Subject: TRANSMISSION WHINE/RINGING NOISE	Bulletin No: 05-001/01
	Last Issued: 04/26/2001

All 1999-2001 Millenia KJ and KL with VINs lower than JM1 TA**** 11 618514.

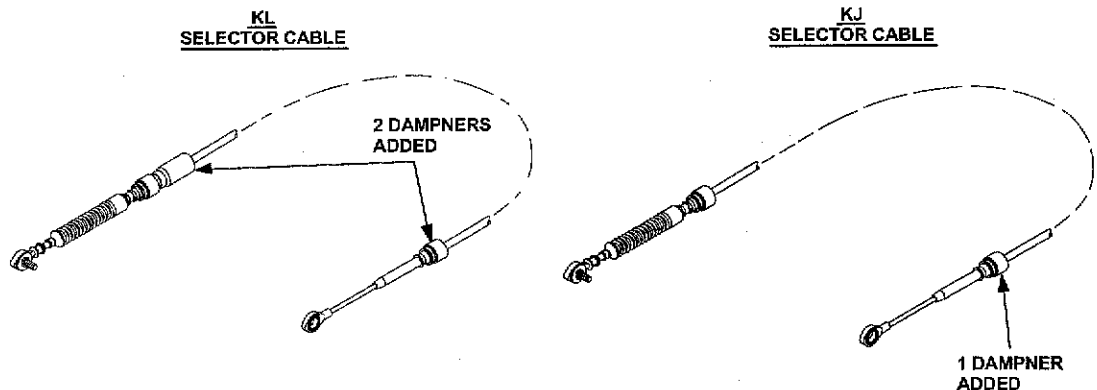
When driving at speeds of 40-70 MPH, a whine or ringing type noise may be heard inside the vehicle during slight acceleration or cruise conditions. This noise is being transmitted inside the cabin through the transmission selector cable. To help reduce this noise, a damper(s) has been added to the selector cable as shown. This noise may appear to be coming from instrument panel/dashboard area.

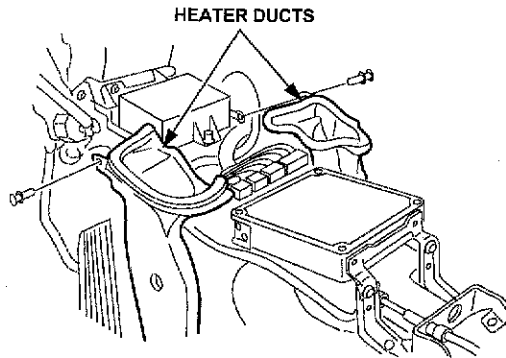
4. Inside vehicle, remove center trim panel (trim around radio and selector lever), selector lever indicator panel, radio unit, PCM and rear bracket (05-18, 01-40).
5. Remove ducts for rear floor heat as shown.
